**LAND DEVELOPMENT CODE**  
***Addendum of Recommended Changes***  
**January 13, 2021**

# Estero Land Development Code

## Addendum of Recommended Changes

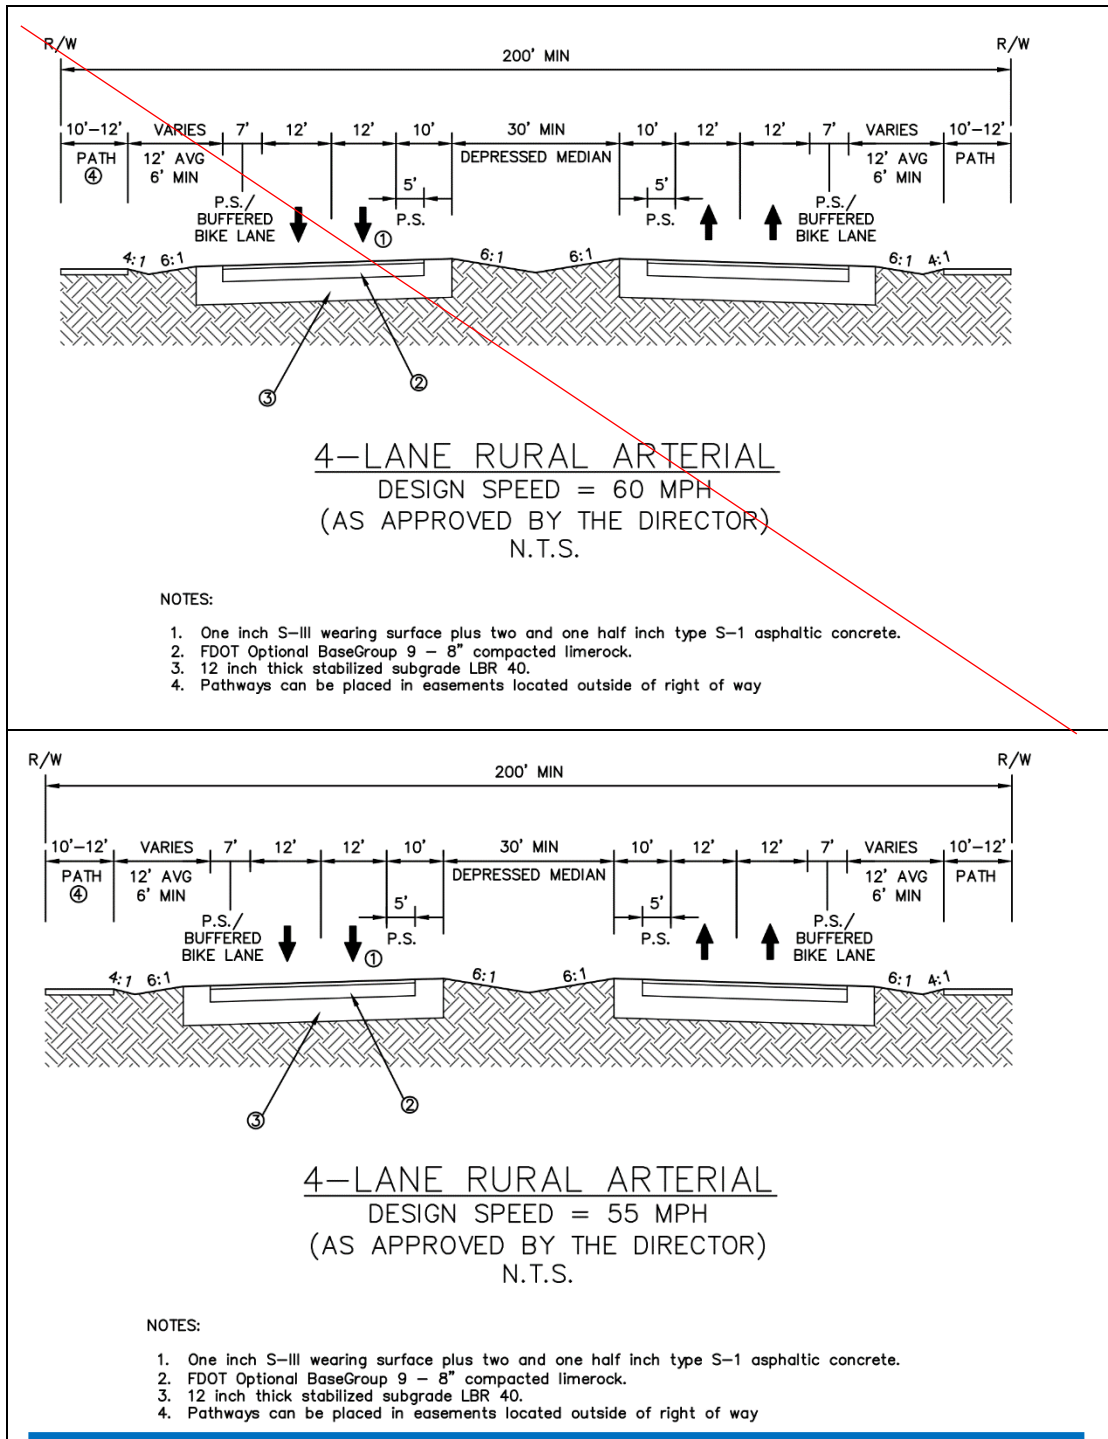
~~1. Pavement width, one-way traffic~~

~~14-foot pavement for one-way traffic with swale drainage or valley gutter drainage, or 16-foot pavements for one-way traffic with curb and gutter drainage. (19 feet minimum from face of curb to face of curb on nonmountable curbs.)~~

2. *Pavement width, two-way traffic*

20-foot pavements for two-way traffic with swale drainage or valley gutter drainage or 24-foot pavement with curb and gutter drainage (27 feet minimum from face of curb to face of curb on nonmountable curbs.)

**62. D.1 Private Local Roads**

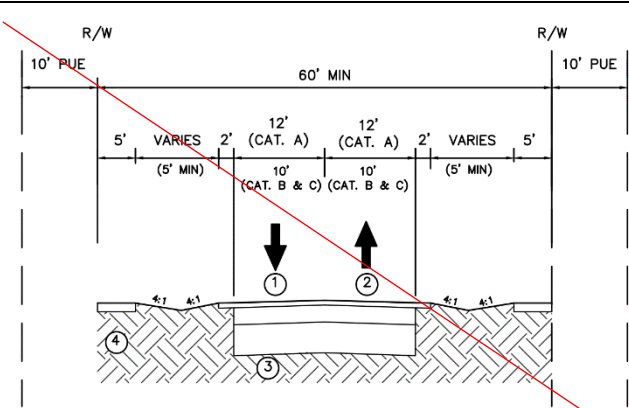
<b>Note</b>	<b>Category B &amp; C</b>	<b>Category A</b>
1	1" Type S-III asphalt concrete [2]	1½" Type S-III asphalt concrete
2	6" Base	8" Base
3	6" Stabilized subgrade	12" Stabilized subgrade
4	Sidewalk — required on one side	Sidewalk — required on one side
<b>NOTES:</b> [1] A ten-foot-wide public utility easement shall be provided abutting each side of the right-of-way.

### 63. D.2 Private Local Roads

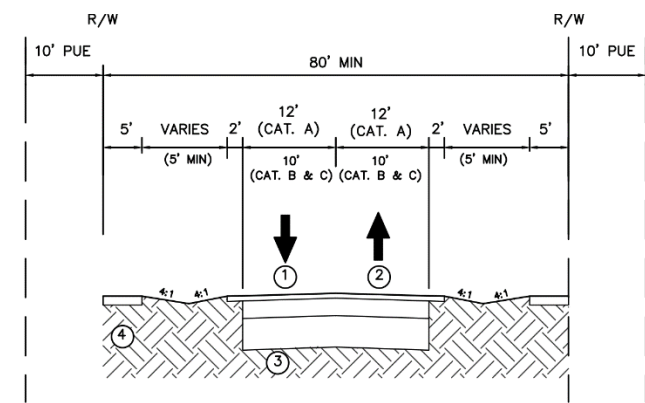
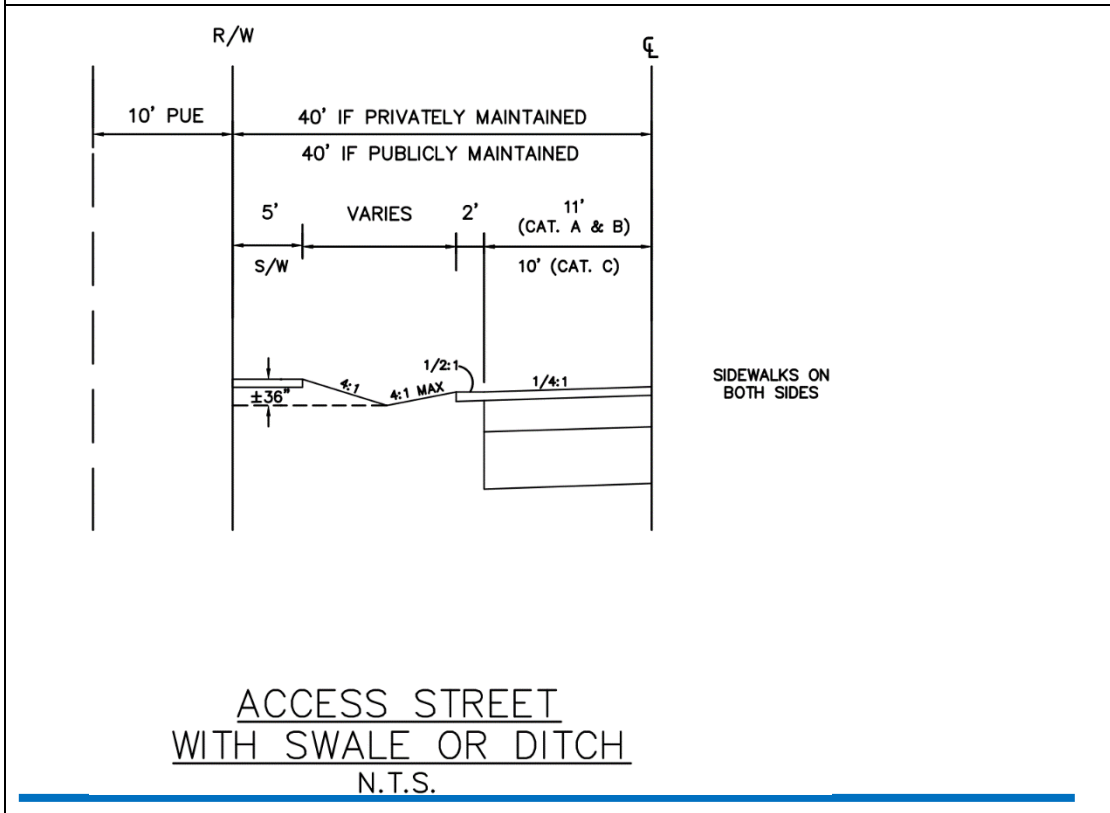
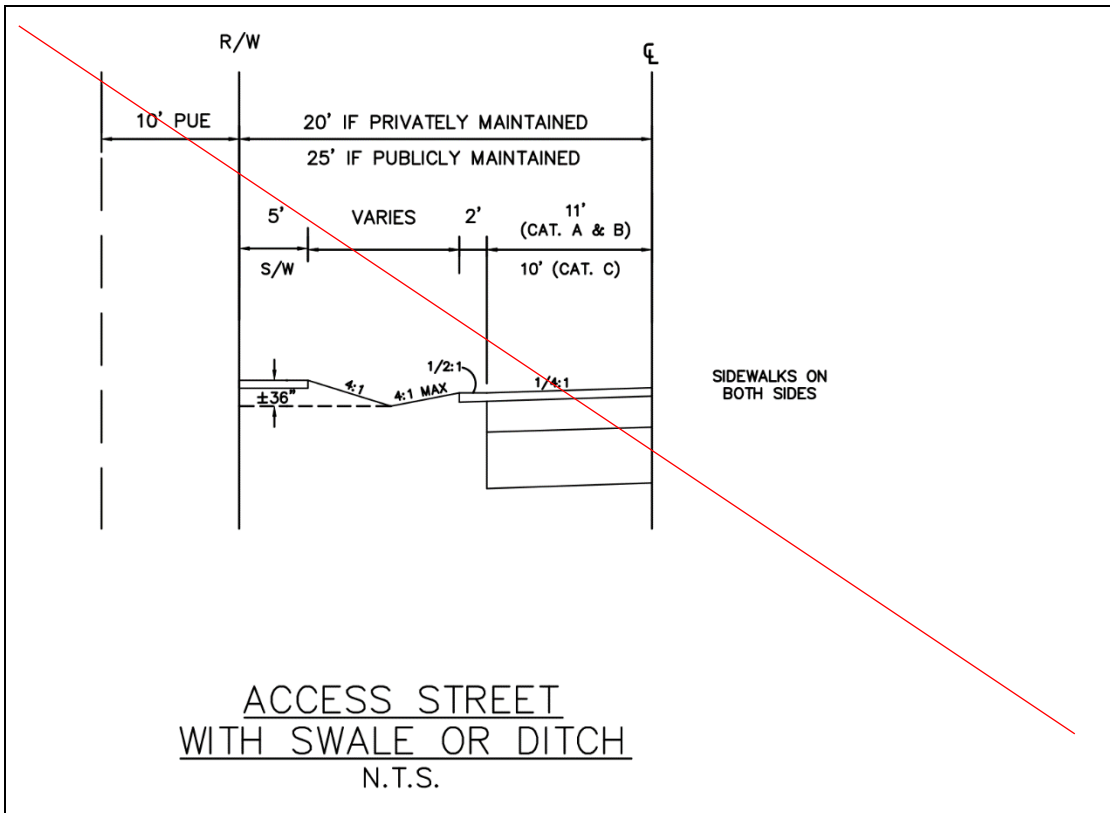
Note	Category B & C	Category A
1	1" Type S-III asphalt concrete <del>[2]</del>	1½" Type S-III asphalt concrete
2	6" Base	8" Base
3	6" Stabilized subgrade	12" Stabilized subgrade
4	Sidewalk — required on one side	Sidewalk — required on one side

65. E.2 Access Roads

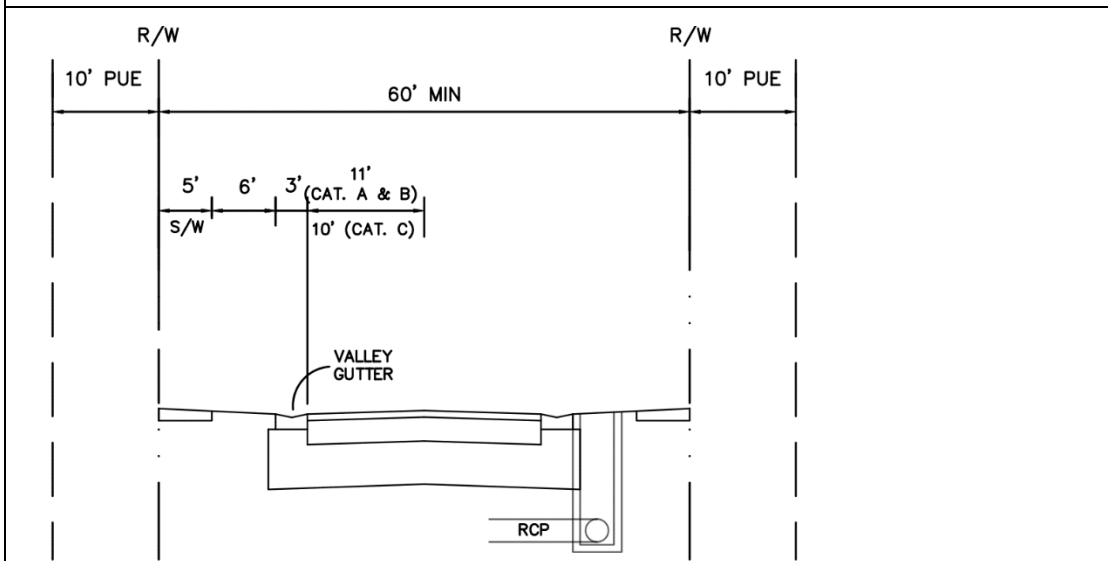
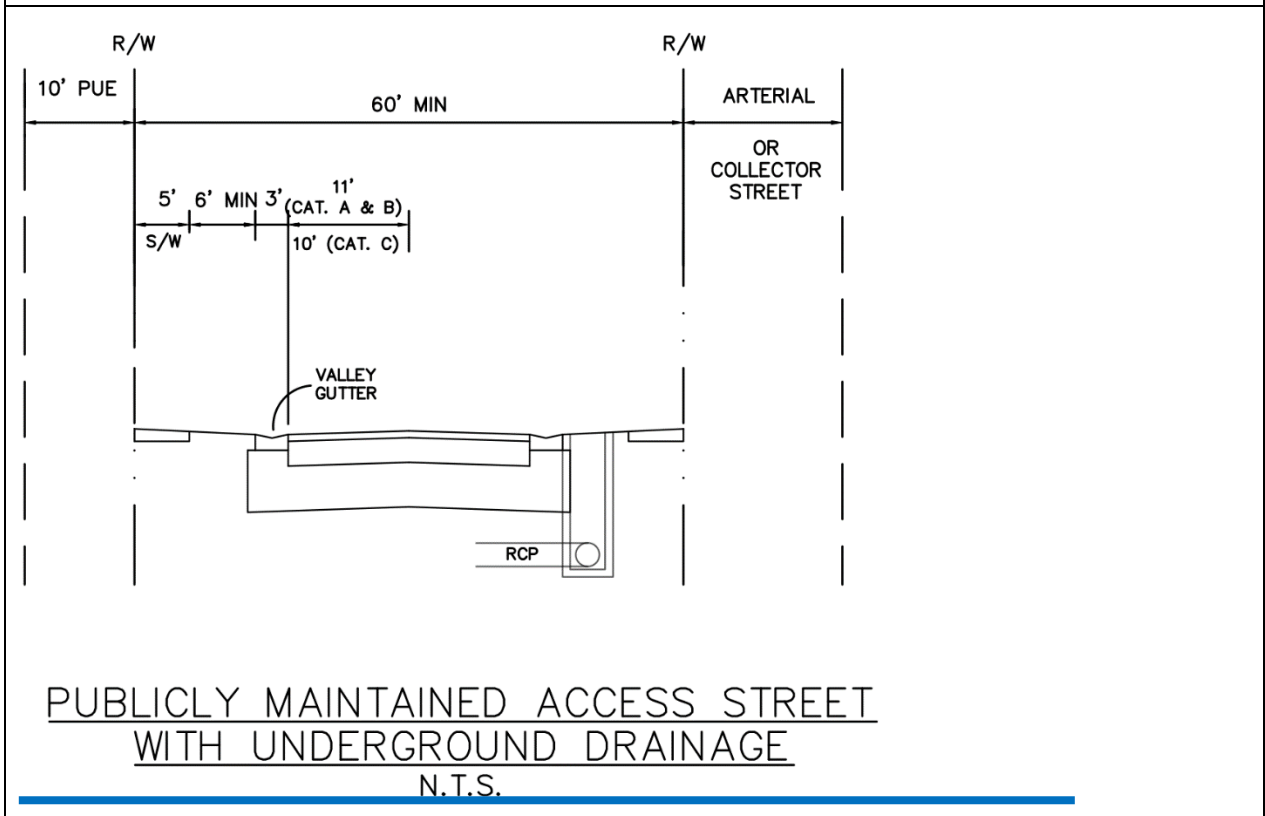
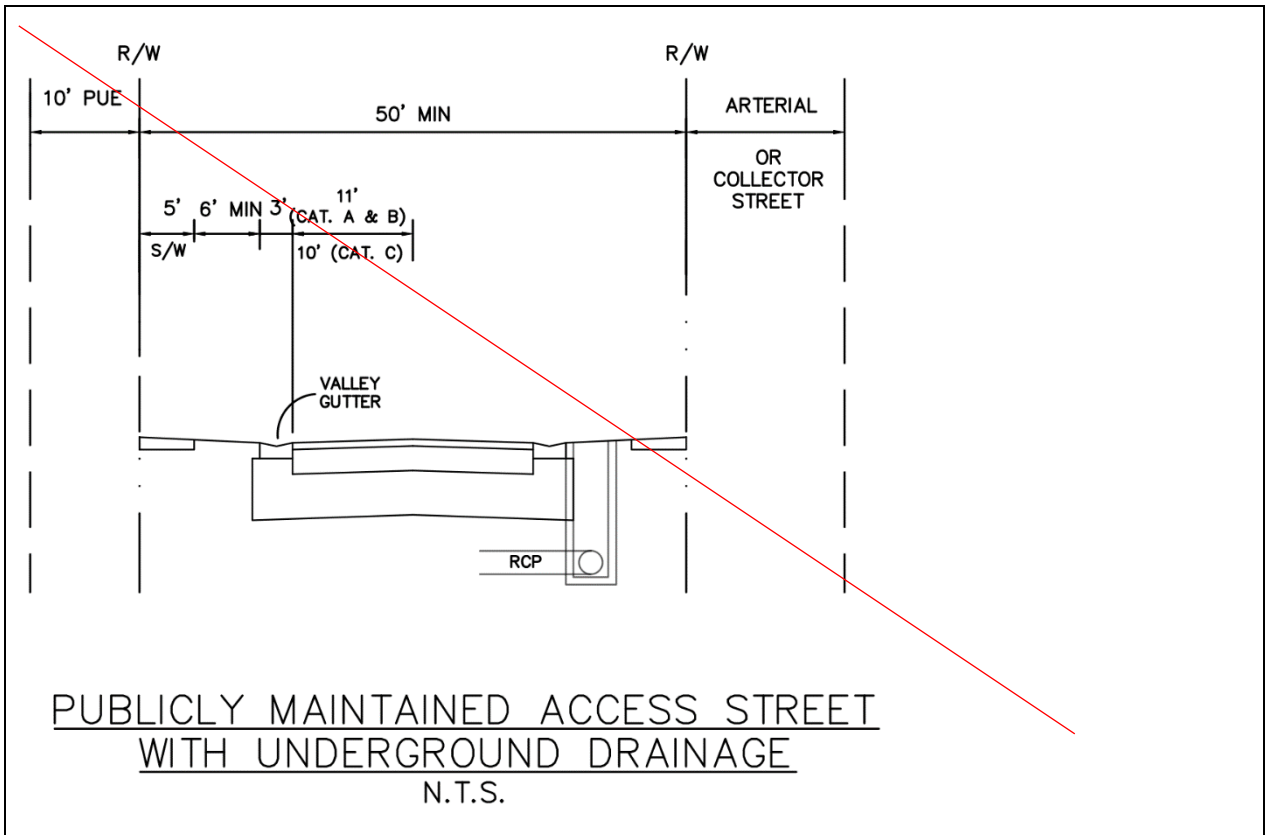
Category	Minimum Pavement Width (feet)	Asphaltic Concrete Surface Course	Base (ft)	Stabilized Subgrade LBR 40 (ft)
A	22	1½" Type S-I <u>or S-III</u>	8	12
B	22	1½" Type S-III <u>or S-III</u>	6	6
C	20	1½" Type S-III <u>or S-III</u>	6	6
